Responses to Council Questions and Comments

10/16/2023

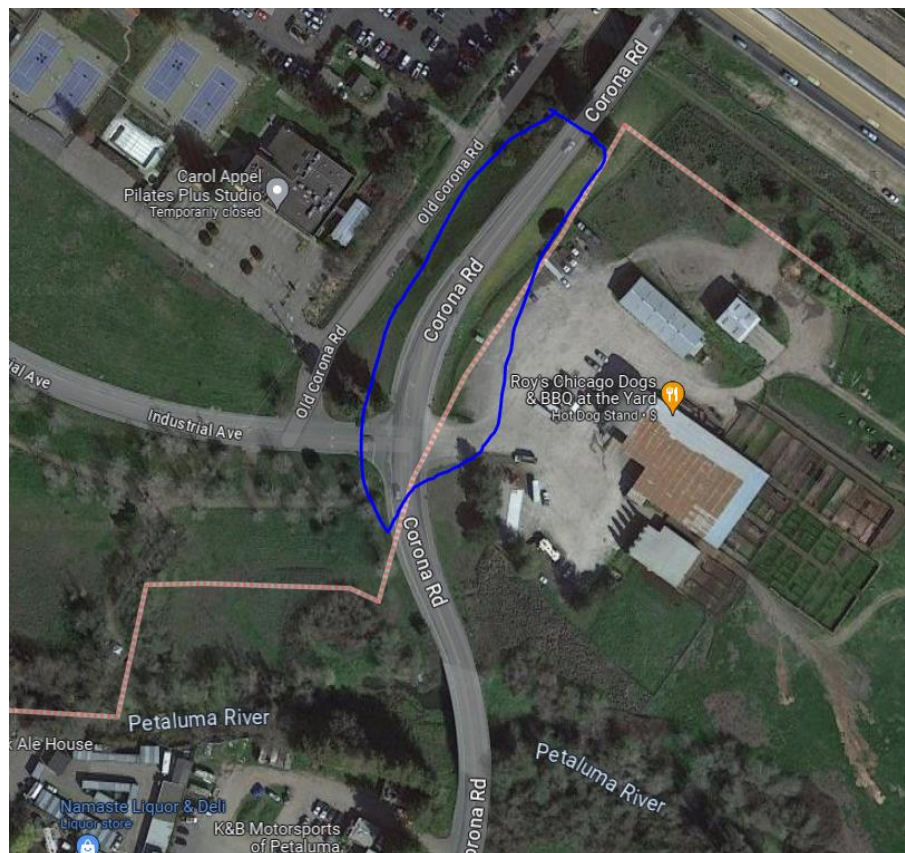
- Question: Is the Significant Items to be a regular item and if so should it be noted in the Nov 6 agenda?
 - Response: The Significant Items schedule is intended to be updated quarterly, with the next update due in January 2024.
- Question: The agenda Nov 6 notes a County agreement for Corona Road. Is this for paving soon or for concept revisions and study?
 - Response: This is for pavement preservation (i.e., slurry seal) that the County is doing nearby. Staff is proposing to partner with the County to have their contractor treat the City's portion/jurisdiction west of the Highway 101 bridge (see photo).
